LiDAR Quality Assurance (QA) Final Report
Sub-Project 2: South Central Nebraska
Nebraska/Kansas LiDAR
January 13, 2010

Submitted to:
USDA-NRCS-Nebraska/
U.S. Army Corps of Engineers

Prepared by:
 **Dewberry**
Fairfax, VA

Reference: U.S. Army Corps of Engineers Contract W912P9-08-D-0507

Figure 8: tile 14T NK 0080 showing part of a building remaining in the ground surface

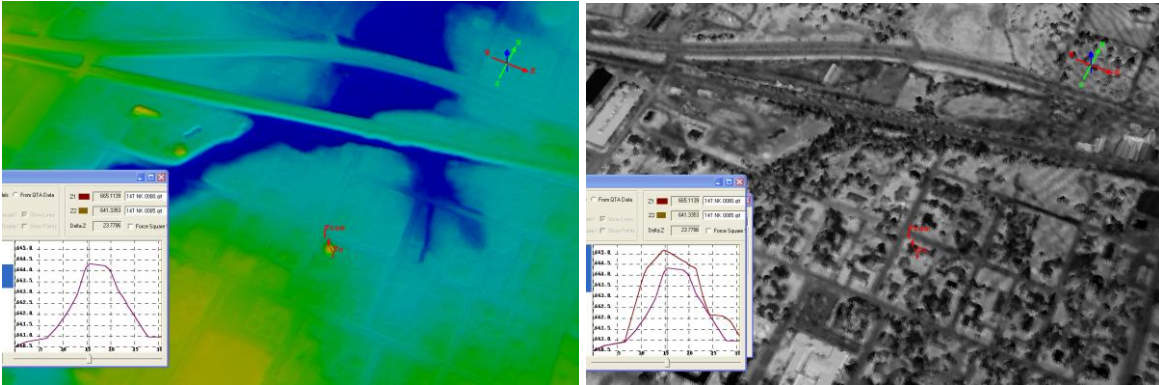
While reviewing the dataset, several buildings were found classified as ground. There is a 2% allowance for building artifacts; therefore these errors do not need to be reprocessed. Figure 8 shows the building remaining in the ground classification. The image on the right shows the full point cloud colored by intensity and the model on the left shows the ground classification colored by elevation. The profile graph shows the elevation difference between the full point cloud and ground. Please see section 6.1 for screenshot thumbnails.

Figure 9: tile 14S NK 0525 showing vegetation in the ground surface

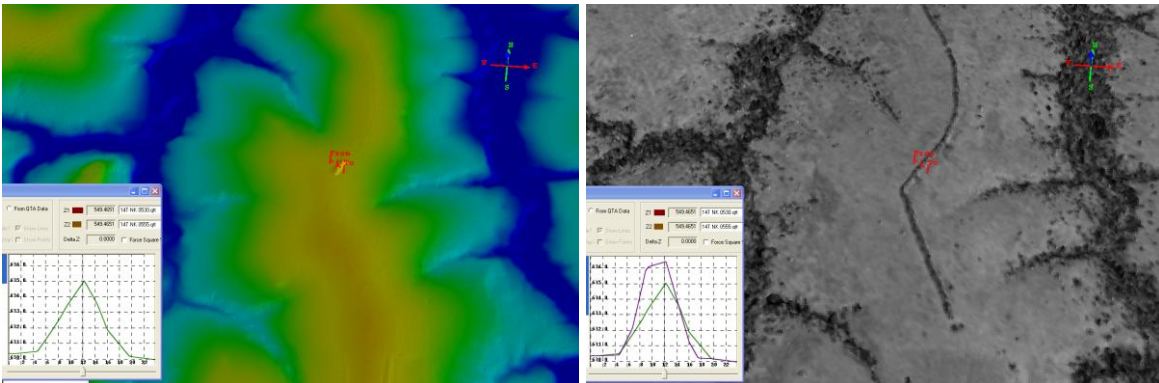
Dewberry also identified several cases of vegetation remaining in the ground classification. There is a 5% allowance for vegetation in the project area so these errors do not need to be reprocessed. Figure 9 shows the full point cloud colored by intensity on the right and the ground classification colored by elevation on the left. The profile graph shows the height of the artifact in the ground model. Please see section 6.1 for screenshot thumbnails.

Figure 10: tile 14T LL 6015 showing a 2 meter divot in the ground surface

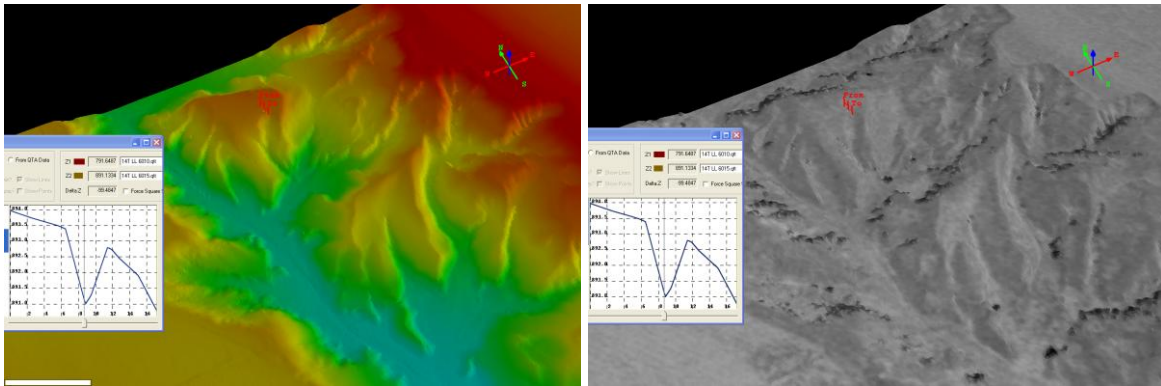
Spikes and divots are points in the dataset that are classified as ground, but are not part of the true ground surface. Spikes could be remnants of trees, buildings, etc that did not get completely removed from the ground, and divots are generally points with errors in GPS time and/or elevation. Spikes and divots must be removed from the final dataset, but Dewberry identified several small divots in the dataset that do not need to be reclassified, because they do not fall far below the ground surface and should not affect the usability of the ground model. Figure 10 shows a divot in the ground model. Please see section 6.2 for screenshot thumbnails.

Figure 11: tile 14T PK 2590 showing a misclassification of ground points

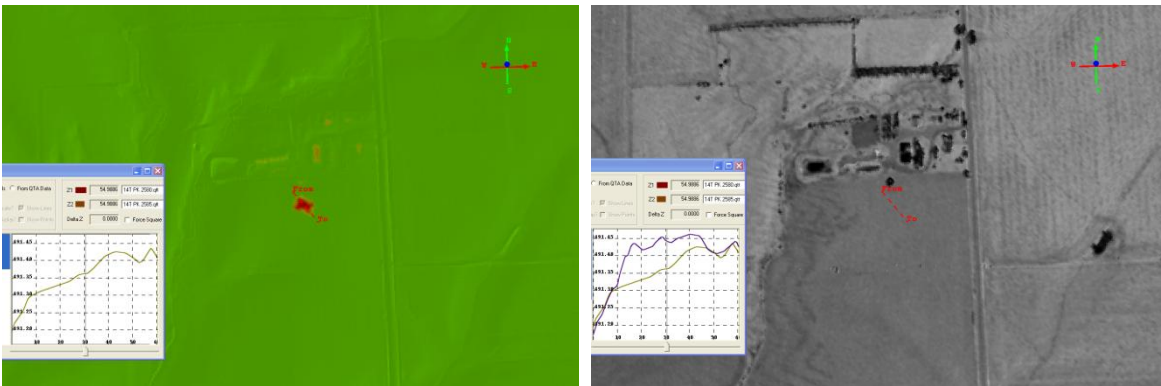
Dewberry identified one small area of misclassification that does not need to be corrected. It covers a very small area and is not near any significant drainage features. Figure 11 shows the misclassification; the image on the left shows the ground density model and the image on the right shows the full point cloud intensity. Please see section 6.4 for screenshot thumbnails.

Figure 12: tile 14T ML 0520 showing noise in the flight line overlap area

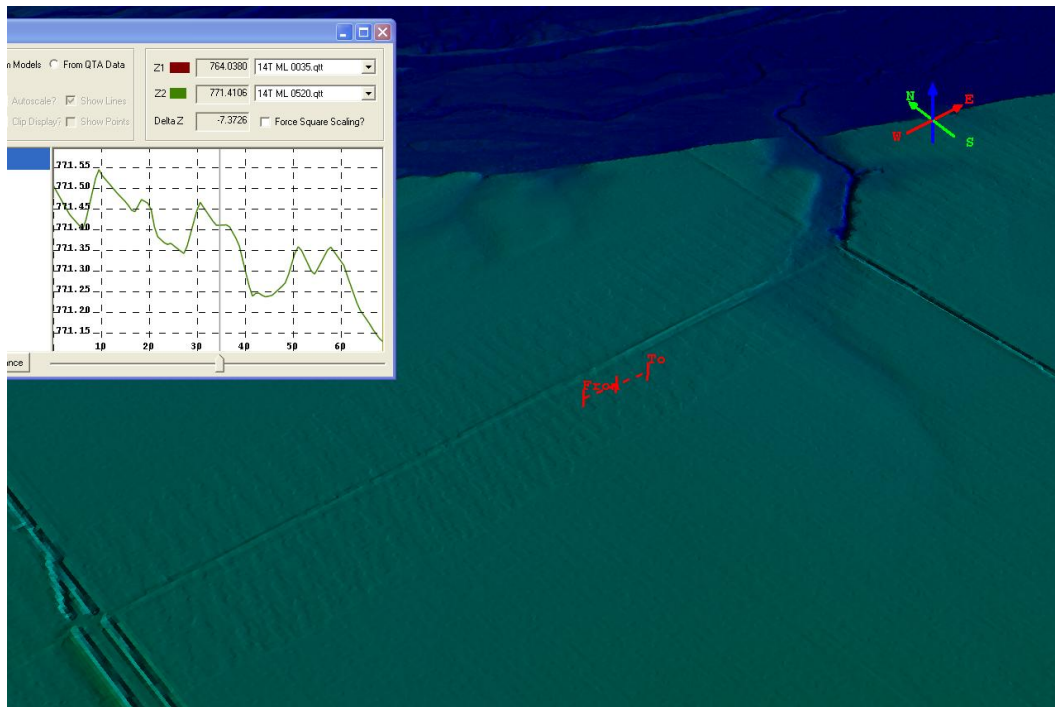
Noise due to small elevation differences between flight lines is a minor error found throughout the dataset. In areas where two or more flight lines overlap, the ground model appears more rough (noisy), as illustrated in Figure 12. All the noisy areas had elevation differences between flight lines of less than 20cm, which is relatively minor and should not affect the usability of the data. Please see section 6.3 for screenshot thumbnails.
